VALUE ENGINEERING PROPOSAL

PROPOSAL NO: S-13

DESCRIPTION Reduce Lock Chamber Armor

DRAWING NO. 1 (CURRENT DESIGN)

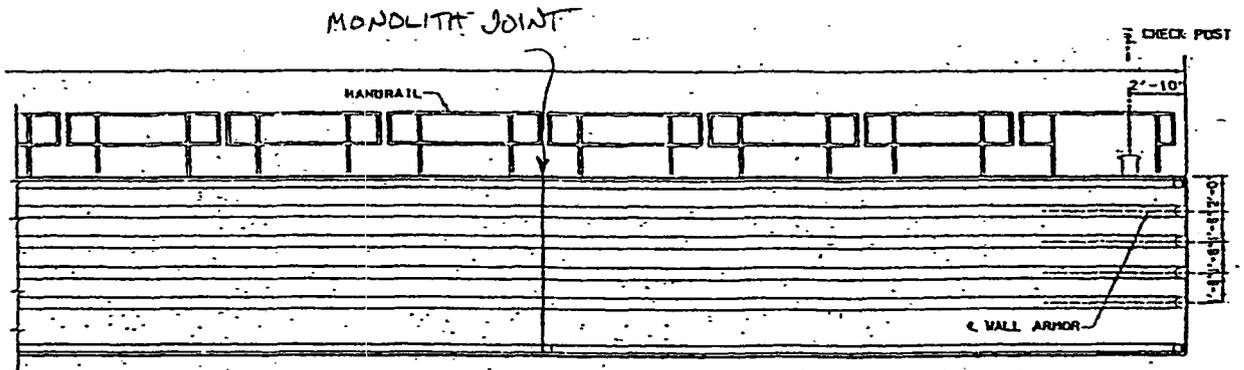
ORIGINAL DESIGN:

Provide steel wall armor on the entire interior of the lock chamber.
(See Drawing No. 1).

DRAWING NO. 2 (PROPOSED DESIGN)

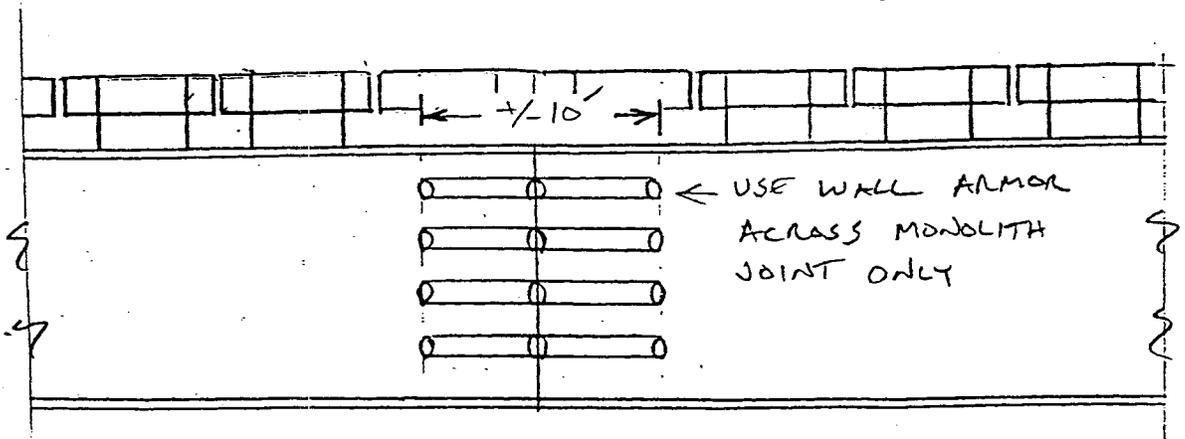
PROPOSED DESIGN:

Provide steel wall armor only across monolith joints.
(See Drawing No. 2).

New locks, Mel Price as an example, have installed chamber wall armor only across monolith (and expansion) joints where edge spalling from longitudinal rubbing could occur. No rubbing damage has occurred on the heavily used Mel Price lock chamber walls as the design appears to work well.
